Access Compliance Report

Public Rights-of-Way

(Curb Ramps)

Intersection ID: 10031479	Main Street: MCINTYRE_AV	Cross Street: N/A	Location: S
ADA ID: DB9DD55994E1	Ramp Type: Perp	Initial Pass/Fail: Fail	Overall Compliance: No
Severity Score: 8.75			
Codes/Mitigation Info/Possible Solution		Field Measurements/Component Compliance

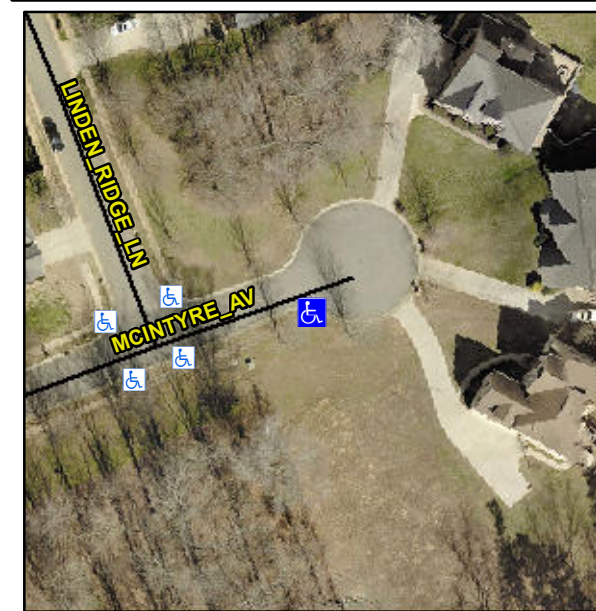
R304.5.1

Compliance	Description	Data	Compliance	Description	Data
N/A	Ramp Length (in)	46.5	Yes	Ramp Slope (%)	6.8
No	Ramp Width (in)	40.0	Yes	Ramp XSlope (%)	1.8
N/A	Flare Type LT	N/A	N/A	Flare Type RT	N/A
N/A	Flare Slope LT (%)	N/A	N/A	Flare Slope RT (%)	N/A
N/A	Flare Traversable LT?	N/A	N/A	Flare Traversable RT?	N/A
N/A	Landing Length (in)	N/A	N/A	DWS Provided?	N/A
N/A	Landing Width (in)	N/A	N/A	DWS Contrast?	N/A
N/A	Landing Slope (%)	N/A	N/A	DWS Length (in)	N/A
N/A	Landing X Slope (%)	N/A	N/A	DWS Full Width?	N/A
N/A	Landing Curb? (Y/N)	N/A	N/A	DWS Offset (in)	N/A
N/A	Shared Landing?	N/A			
N/A	Gutter Ponding?	N/A	N/A	Gutter Slope (%)	N/A
N/A	Gutter Lip Ht (in)	N/A	N/A	Gutter X Slope (%)	N/A
N/A	Painted X Walk1?	No	N/A	Painted X Walk2?	N/A
	X Walk 1 Direction	To N		X Walk 2 Direction	N/A
N/A	X Walk 1 Width (in)	N/A	N/A	X Walk 2 Width (in)	N/A
	X Walk 1 Slope (%)	4.6		X Walk 2 Slope (%)	N/A
	X Walk 1 X Slope (%)	7.7		X Walk 2 X Slope (%)	N/A

Remove & Replace Entire Ramp.
